San Francisco Bay Regional Water Quality Control Board

DATE: April 12, 2016

**SUBJECT: GEOMORPHIC INDICATIONS FOR LONG-TERM DEPOSITIONAL
ENVIRONMENT ON BERRYESSA CREEK IN THE UPPER BERRYESSA
CREEK FLOOD RISK MANAGEMENT PROJECT**

Figure 1

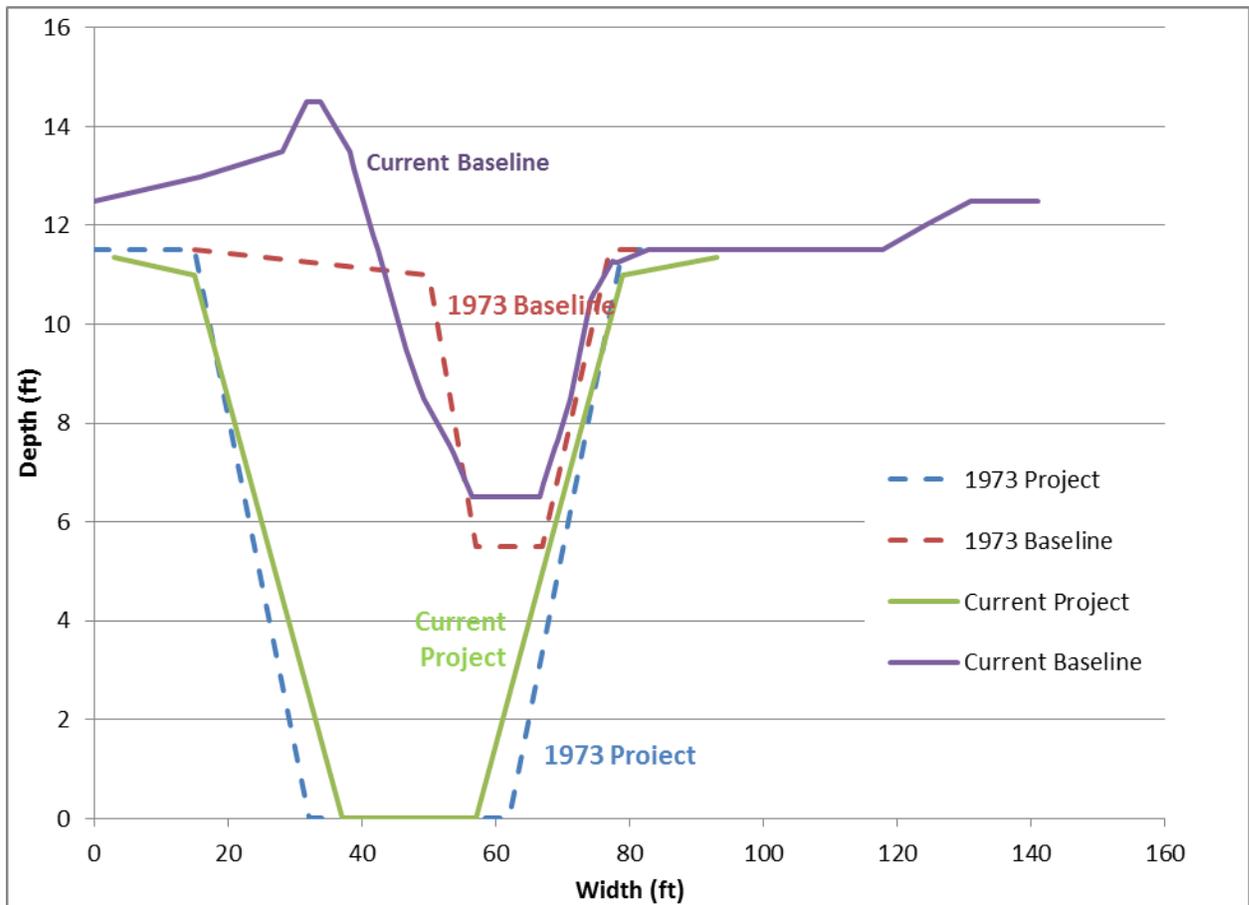
1. Current SCVWD sediment maintenance records indicate that over 20,000 cubic yards of sediment has been removed within the proposed project reach (and not counting upstream or downstream sediment removal) since early 1980s. A September 2015, field trip and recent April 2016 trip observations indicate new point and center bars and the continuing dynamics of a depositional environment.
2. Comparison of cross sections from 1973 as-built surveys with current and proposed project conditions is another line of geomorphic evidence supporting the finding that the project reach will be depositional in the future. Figure 1 below compares baseline and project conditions from 1973 with current baseline and proposed Project conditions at a typical cross section along Reach 17 (i.e., station no.186 +30; approximately 2,300 feet downstream of Interstate 680).

The current active channel in the Project area, and both upstream and downstream channel reaches, averages 10 to 20 feet wide and approximately 4 to 6 feet deep as observed during the September 2015 field survey of Upper Berryessa Creek. These dimensions are within a larger 30 to 40 foot wide, approximately 8 foot deep trapezoid. These active channel dimensions are what would be expected from a watershed of this size in the East Bay of approximately 15 mi². In 1973, the mean baseline width of the active channel was 20 to 25 feet, and a depth of about 5 feet; very close to what we are currently observing (Figure 1, red dotted line of 1973 and purple line of current cross sections). The original 1973 project

widened the project channel to 75 to 80 feet, just as the current project is widening this channel to 60 to 80 feet (Figure 1, blue dotted line of 1973 and green line of currently proposed project). Therefore the project proposal is essentially a maintenance project to return to the 1973 project dimensions as clearly illustrated by Figure 1.

Figure 2
Shear Stress Along the Project Reach Under Baseline and Project Conditions
During the 100-yr Flood

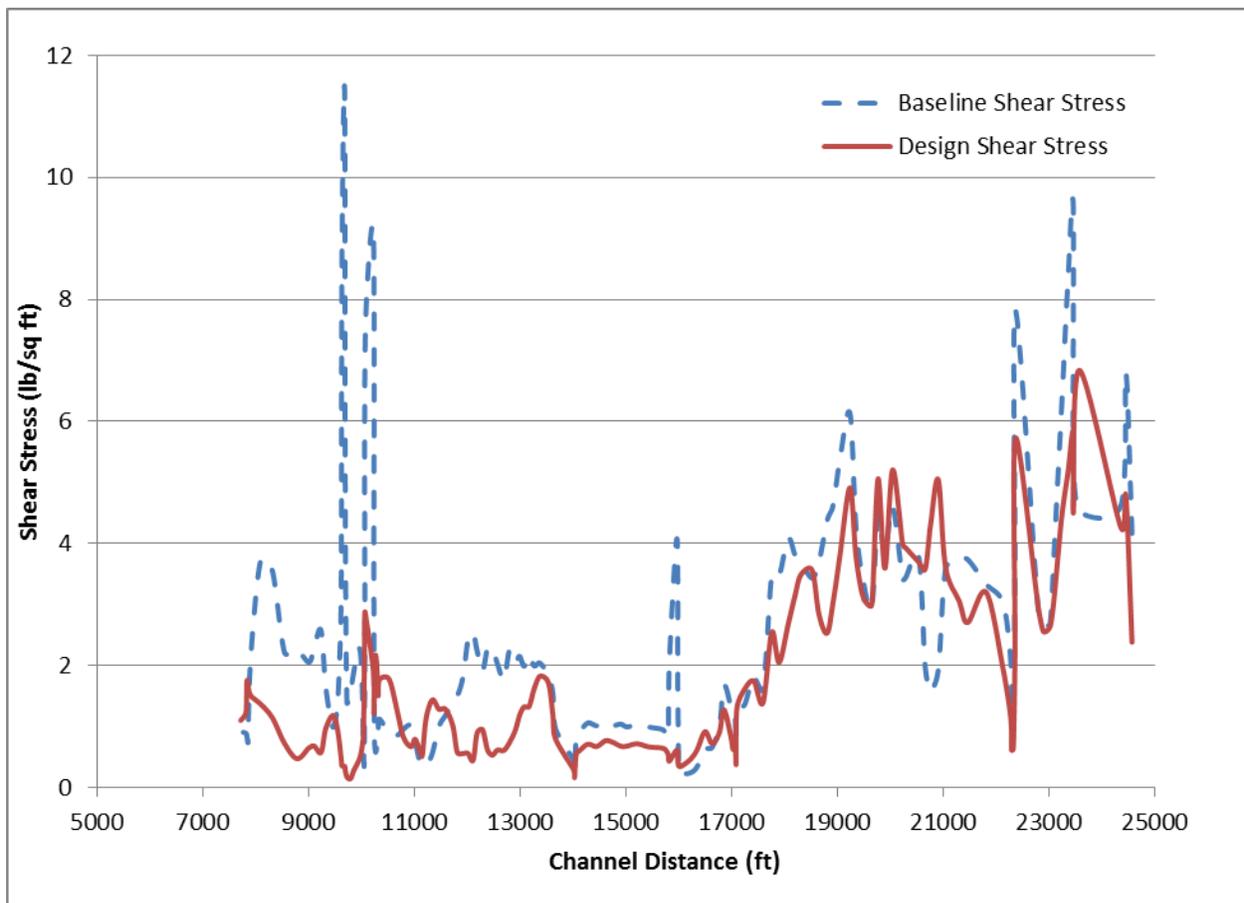
3. A shear stress comparison between current baseline conditions and proposed project conditions indicates a reduction of channel shear stresses, further leading to the conclusion that project conditions are going to be depositional, and are not going to significantly change channel dynamics toward erosional as suggested by the District.
